Application for Licence Amendment

Licence Number	L5529/1988/12
Licence Holder	Mt Magnet Gold Pty Ltd
ACN	008 669 556
File Number	DER2016/001228-1
Premises	Mt Magnet Gold MOUNT MAGNET WA 6623 M58/30, M58/79, M58/121, M58/136, M58/172, M58/181, M58/185, M58/186, M58/187, M58/191, M58/193, M58/202, M58/205 and M58/234
Date of Report	3 June 2022
Decision	Granted

**MANAGER, RESOURCE INDUSTRIES
INDUSTRY REGULATION**

Figure 3: Dewatering points in relation to sensitive receptors

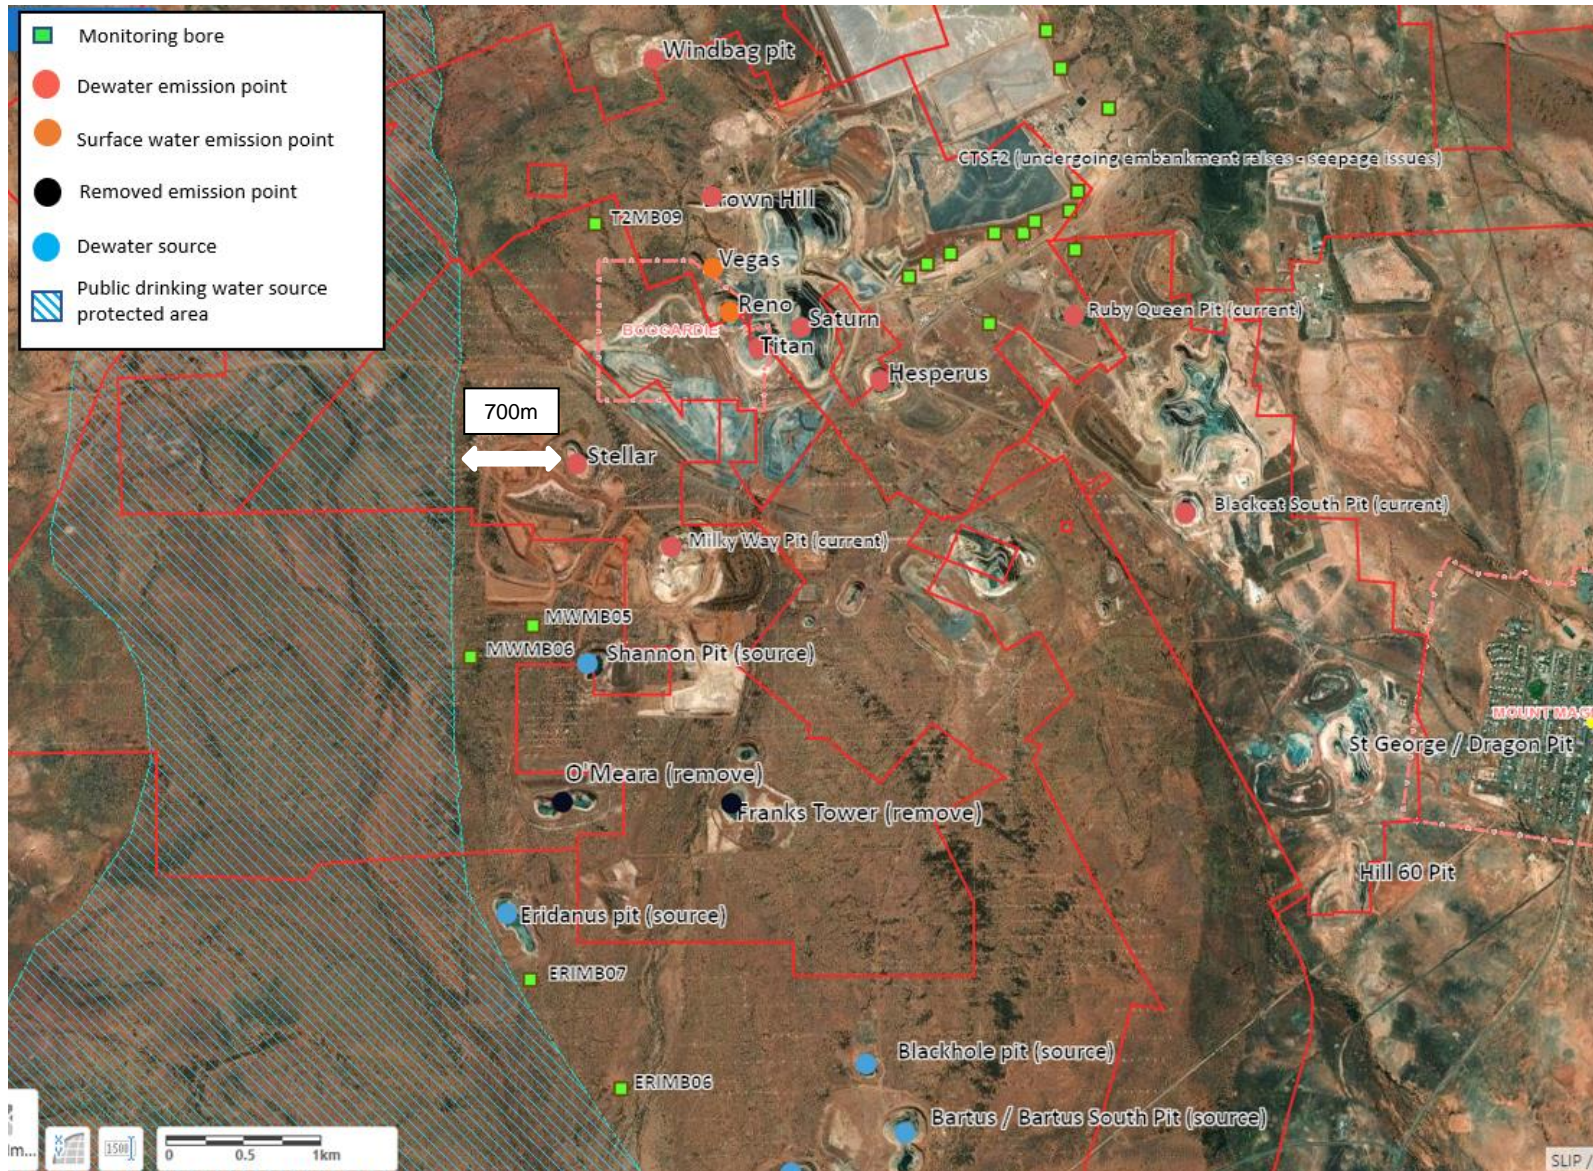
Results for one sample (taken June 2021) have been provided for each of the pits, including the Stellar Pit (receiving mine dewater). As the Stellar Pit is only 700m east from the PDSWA (Figure 3), results from the source pits have been compared to the 2021 drinking water guidelines. Arsenic, nitrate and antimony were found to exceed drinking water criteria for some of the source pits. A summary of exceedances is provided in Table 7 below. No results exceeded health criteria for water currently within the Stellar Pit.

Results for one sample (taken June 2021) have been provided for each of the pits, including the receiving pits. As the Windbag Pit is only 1.3km east from the PDSWA (Figure 3), results have been compared to 2021 drinking water guidelines. The water currently in the receiving pits exceeded criteria for arsenic, boron, molybdenum, selenium and nitrate (summarised in Table 9 below). June 2021 sampling indicates water currently in the receiving pits range between 620 – 12,000mg/L total dissolved solids, the most saline being the Windbag Pit (the second closest pit to the PDSWA¹, being 1.3km east).

Figure 4: Basement geology in the Mt Magnet mining area (Anand et al., 2003)

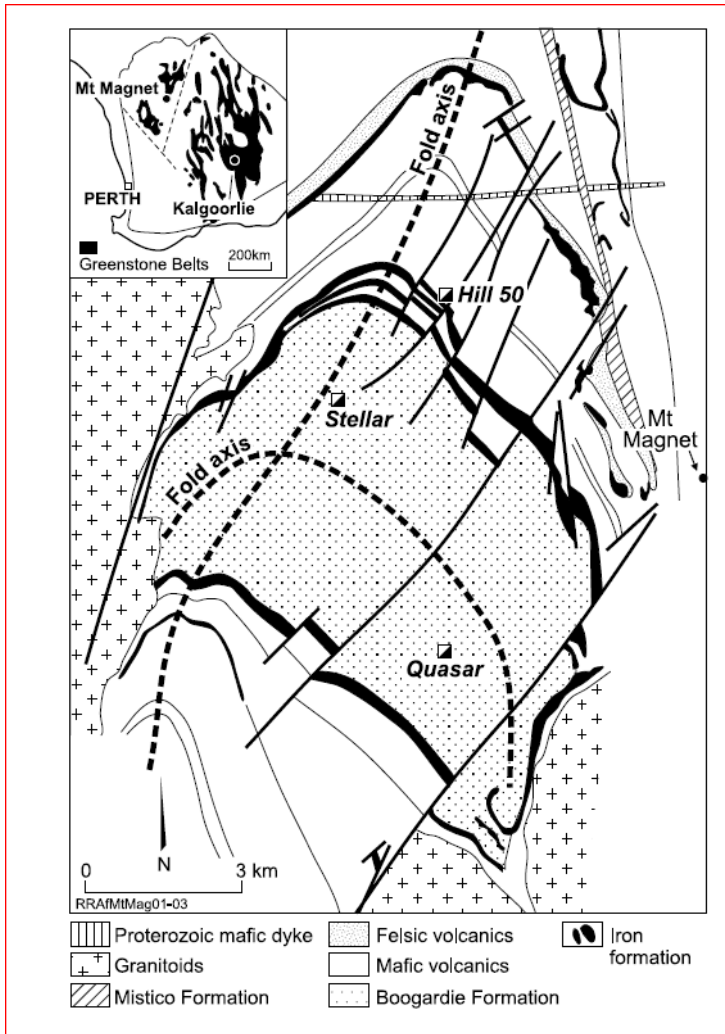
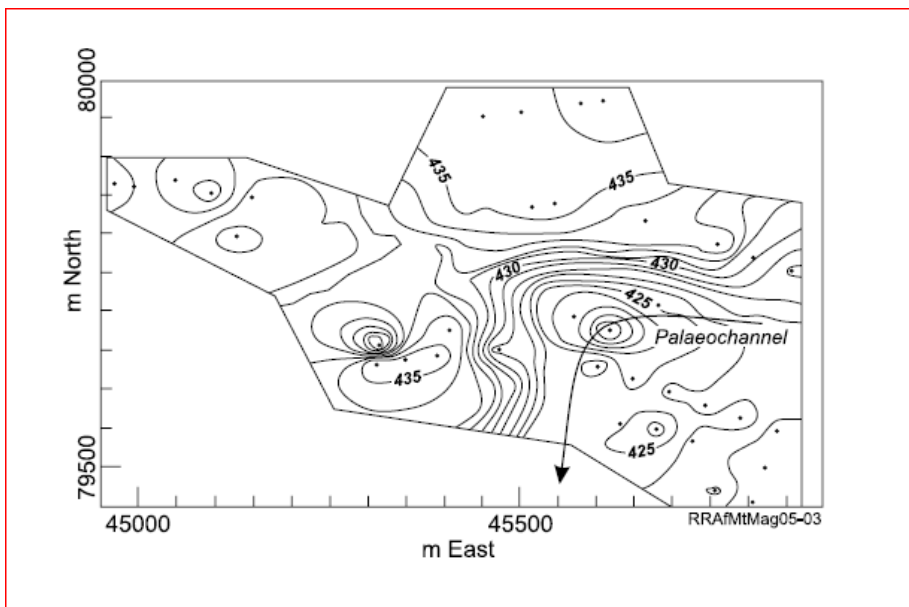
Advice from the department’s hydrogeologists indicates that in the Mt Magnet mining area, groundwater flow takes place both in basement rocks and in permeable regolith materials that overlie the basement rocks. Basement rocks in the Mt Magnet mining area mostly consist of highly altered ultramafic rocks of the Boogardie Formation (Anand *et al.*, 2003). Bedrock in the area is cut by a large number of faults with a south-west to north-east direction. The altered ultramafic and volcanic rocks in the area generally have a very low hydraulic conductivity. Groundwater flow in these rocks is therefore likely to take place predominantly in the fractured zones.

Alluvial sediments in creeks contain groundwater that is locally fresh to saline, and groundwater also occurs in palaeochannels within bedrock near some of the mine pits. This is particularly the case near the Stellar pit, where a palaeochannel contains a 10 to 20 metre thickness of potentially permeable sediments (Anand *et al.*, 2003). This feature is likely to transport groundwater flow in a south-westerly direction (Figure 5), but it is not known if there is a hydraulic connection between this feature and the modern alluvial channel that contains the fresh groundwater that forms the Mt Magnet town water supply. However, there is a risk that this palaeochannel could be a significant conduit for groundwater flow away from the Stellar pit.

The magnitude of risk depends on the water elevation within Stellar Pit. If the elevation of the pit lake lies below the base of the palaeochannel sediments, then groundwater flow out of the Stellar pit is unlikely in these materials.

Advice from the department's hydrogeologists indicates the overall likelihood of seepage impacting the PDWSA to be low. This is due to:

Figure 6: Proposed monitoring bore locations

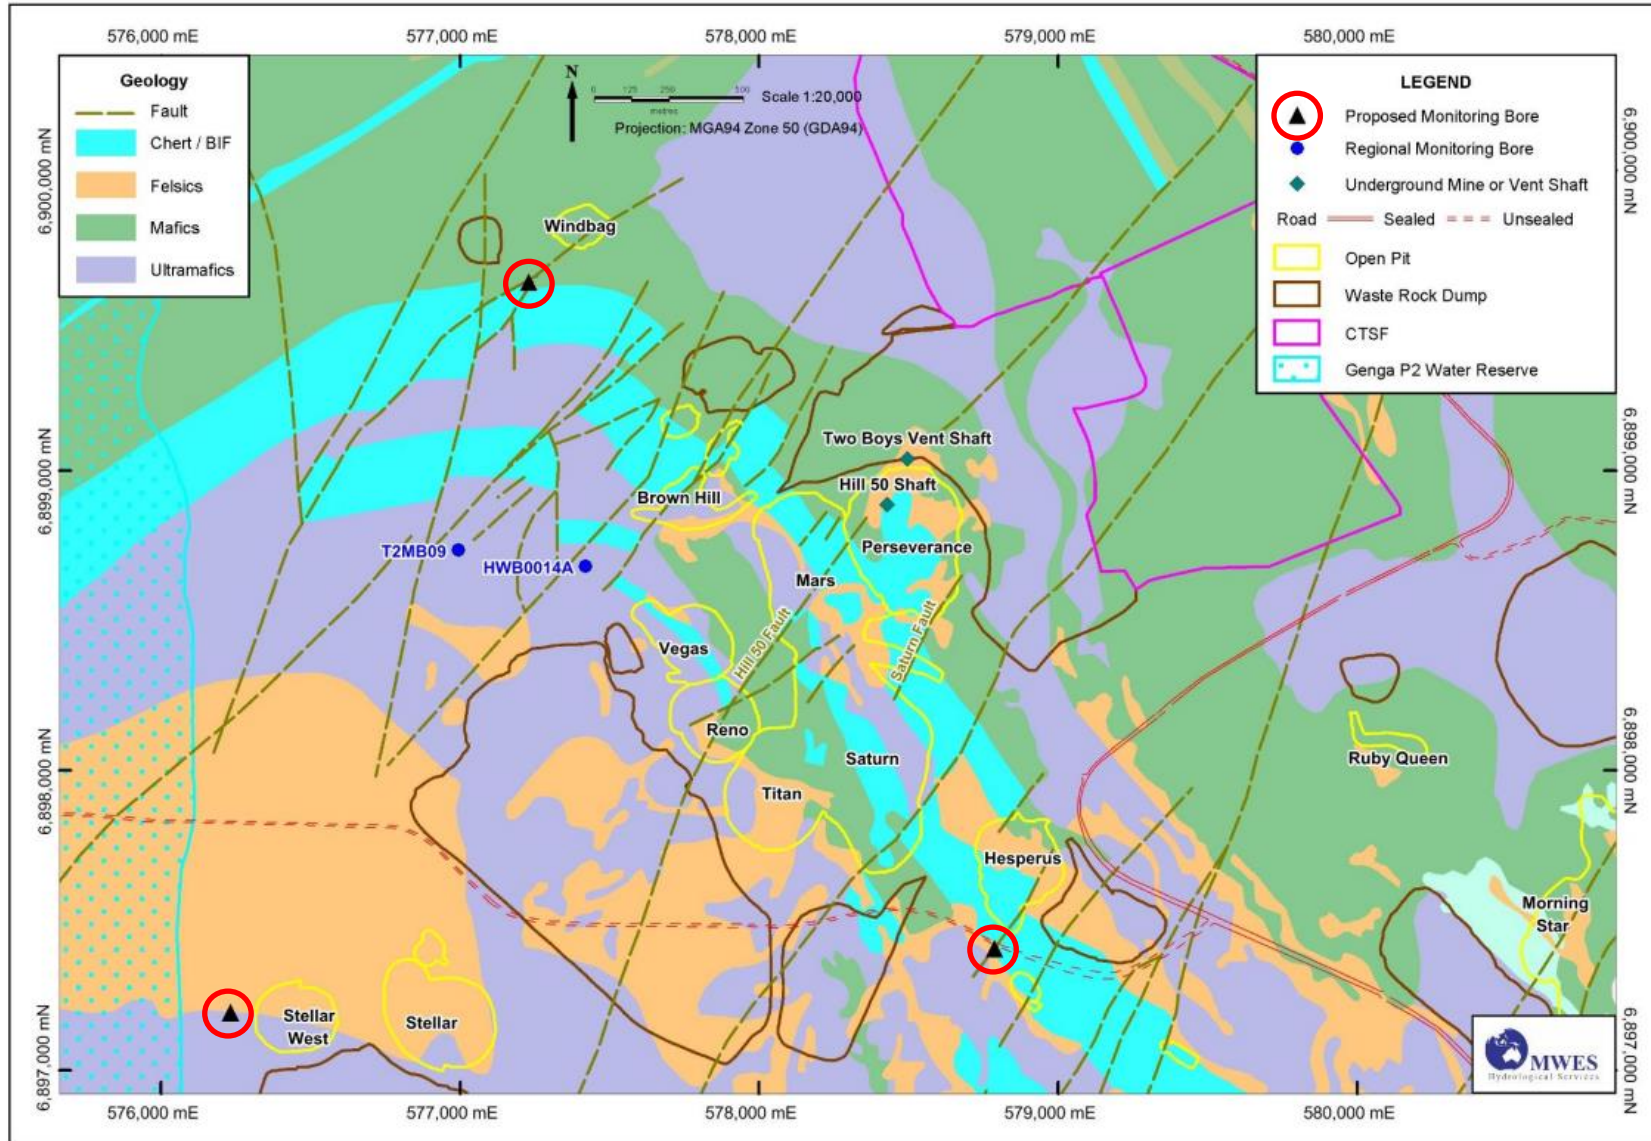
- Proposed monitoring bores are shown in Figure 6 below. The applicant have targeted structural features (i.e. higher permeability areas which may allow preferential groundwater flow) as below:

- Southwest of the Windbag Pit along an inferred fault zone and near the contact between mafic and chert/ banded iron formation rocks;
 - South of the Hesperus Pit along an inferred fault zone and in a region of potentially fractured felsic rocks; and

- West of the Stellar West Pit along a contact between felsic and ultramafic rocks.

DWER notes that allowing Stellar Pit to reach capacity would contradict the previously mentioned commitment for zero seepage and maintaining pit lake levels below the surrounding groundwater level;

<u>Ambient environmental quality monitoring</u> Modification of condition 3.4.1	Condition 3.4.1 has been modified to include monitoring for the bores proposed by the applicant for installation. Applicant proposed biannual monitoring for monitoring wells installed southwest of Windbag pit and south of Hesperus pit has been placed on the licence as a regulatory control. As Stellar pit is only 700m east of the PDSWA, quarterly water quality monitoring for monitoring wells installed west of Stellar pit has been conditioned.
<u>Water balance monitoring</u> New condition 3.5.2	As Stellar pit is only 700m east of the PDSWA, a requirement for quarterly water balance monitoring has been placed on the licence.

Figure 8: Aboriginal Heritage Sites

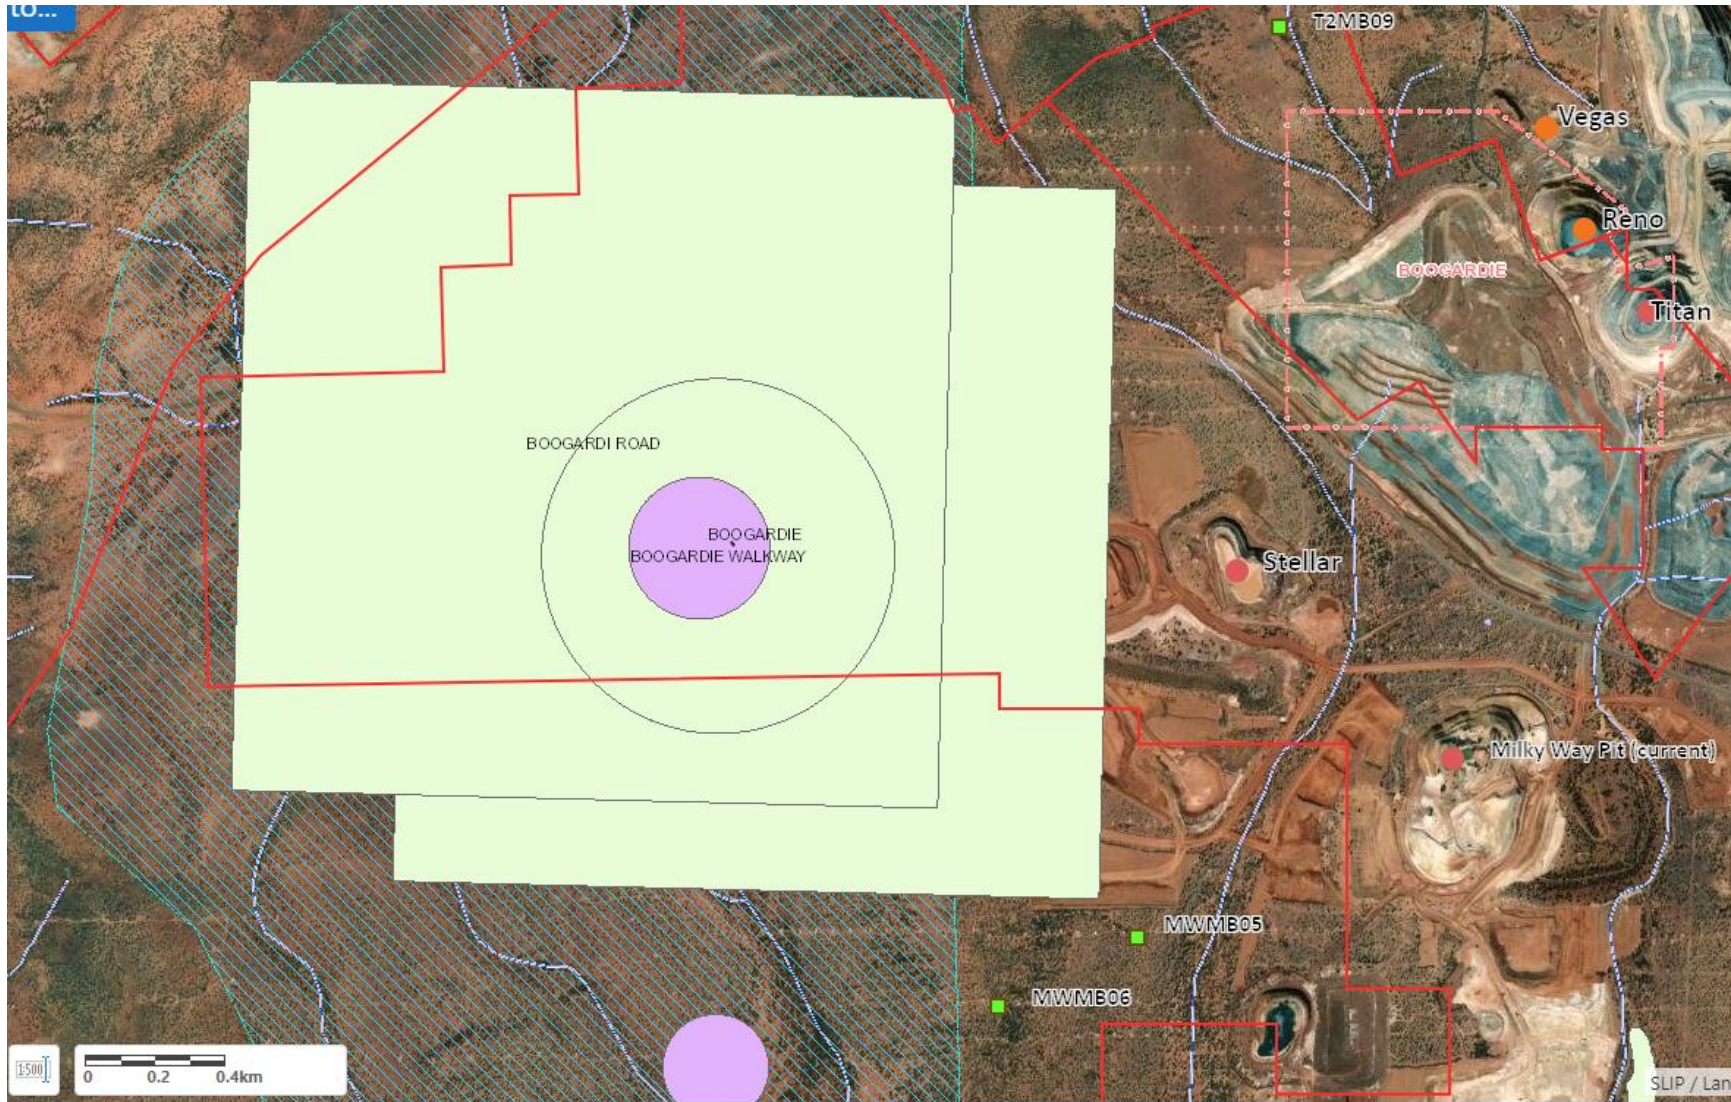
DWER notes that there are a number of Aboriginal Heritage sites within proximity of proposed dewater discharge to Stellar pit (Figure 8), the closest being Boolgardie site ID 4417, 300m west of Stellar pit. Whilst, these are not considered included within the risk assessment of this report, the applicant should note that under the *Aboriginal Heritage Act 1972* consent is required from

the Minister for Aboriginal Affairs for any activity which could negatively impact Aboriginal heritage sites.

DWER notes that there are a number of Aboriginal Heritage sites within proximity of proposed dewater discharge to Stellar pit, the closest being Boolgardie site ID 4417, 300m west of Stellar pit. Under the *Aboriginal Heritage Act 1972* consent is required from the Minister for Aboriginal Affairs for any activity which could negatively impact Aboriginal heritage sites. Particularly, for

installation of groundwater monitoring bores to the west of Stellar pit, the Licence Holder is advised to consult with the Department of Planning, Lands and Heritage for any approvals which may be required under the *Aboriginal Heritage Act 1972*.
